Dimension Changes, Douglas Avenue — Sta. 50+85R to Sta. 53+10R; Sta. 58+26R to Sta. 60+55R; Sta. 54+55R to Sta. 56+78R

REVISED 4/99

STREETSCAPES
PROJECT NAME

DOUGLAS AVE. STA. 48+00 TO 53+00
SHEET TITLE

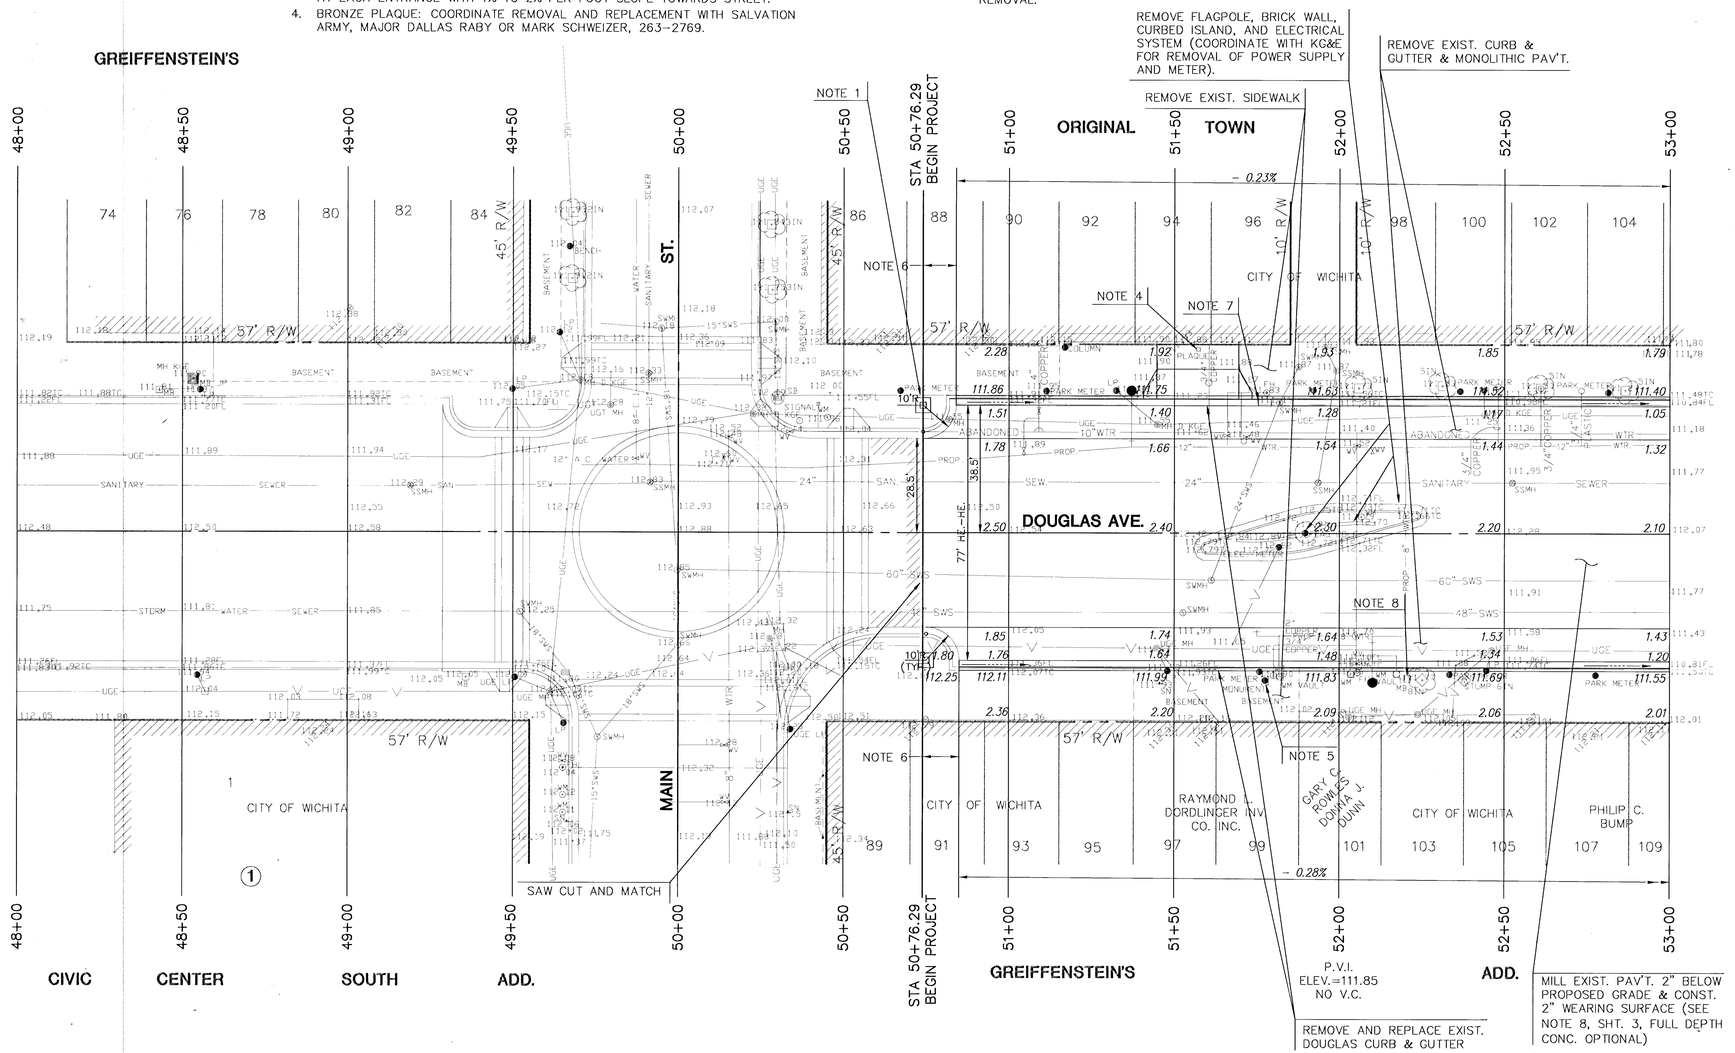
Sheets 7, 8, & 9
Plans show 38.5' centerline–H.E. Change to 37.5' centerline–H.E. South curb to clear street light foundations, and as approved by the Engineer. Adjust locations of curb inlets Lines 1B, 2B and 3D accordingly.

Sheet 12
Adjust line 1B, 2B and 3D curb inlet locations and RCP length accordingly.

Sheets LS 1.01, 1.02, 1.03 & 5.01
Sidewalk width south side of Douglas, adjust accordingly.
